APPLICATION NO.	FILING DATE	FIRST NAMED INVENTOR	ATTORNEY DOCKET NO.	CONFIRMATION NO.
10/511,119	03/17/2005	Patrice Cardine	60130-2246	8871
26996 7590 11/18/2009 CARLSON, GASKEY & OLDS, P.C. 400 WEST MAPLE ROAD			EXAMINER	
			REDMAN, JERRY E	
SUITE 350 BIRMINGHAM, MI 48009			ART UNIT	PAPER NUMBER
			3634	
			MAIL DATE	DELIVERY MODE
			11/18/2009	PAPER

Application No. Applicant(s) 10/511,119 CARDINE ET AL. Office Action Summary Examiner Art Unit Jerry Redman 3634 -- The MAILING DATE of this communication appears on the cover sheet with the correspondence address --Period for Reply A SHORTENED STATUTORY PERIOD FOR REPLY IS SET TO EXPIRE 3 MONTH(S) OR THIRTY (30) DAYS. WHICHEVER IS LONGER, FROM THE MAILING DATE OF THIS COMMUNICATION. Extensions of time may be available under the provisions of 37 CFR 1.136(a). In no event, however, may a reply be timely filed after SIX (6) MONTHS from the mailing date of this communication. If NO period for reply is specified above, the maximum statutory period will apply and will expire SIX (6) MONTHS from the mailing date of this communication - Failure to reply within the set or extended period for reply will, by statute, cause the application to b

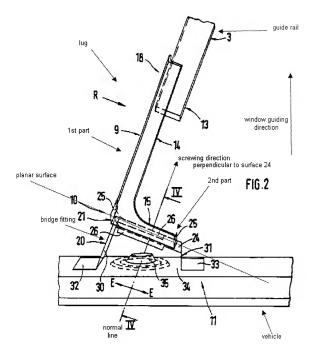
Claims 2-10, 12, 15, 17, 19, 21, and 23 are rejected under 35 U.S.C. 102(b) as being anticipated by EP patent no 0 262 283 A1 to Rieder. As shown in Figure 2 below, EP patent no 0 262 283 A1 to Rieder discloses a vehicle body (11) comprising a window regulator having a lug (9), a window guide rail (3) defining a window guiding direction with the guide rail (3) having two ends with the lug (9) attached to one end, a bridge fitting (20) having an upper surface (24), the lug (9) further comprises a first part (14) for fixing to the guide rail (3), and a second planar part/portion having an oblong hole (15 and 21 is the second part and 28 is the oblong hole and only the portion that contacts upper surface 24 is the second part) defining a plane fixed by screwing (22 and 23, see figure 3) onto the bridge fitting (20) with the screwing direction being a normal line (at an angle of about 45 degrees) substantially perpendicular to the plane and the normal line is inclined relative to the window guiding direction.
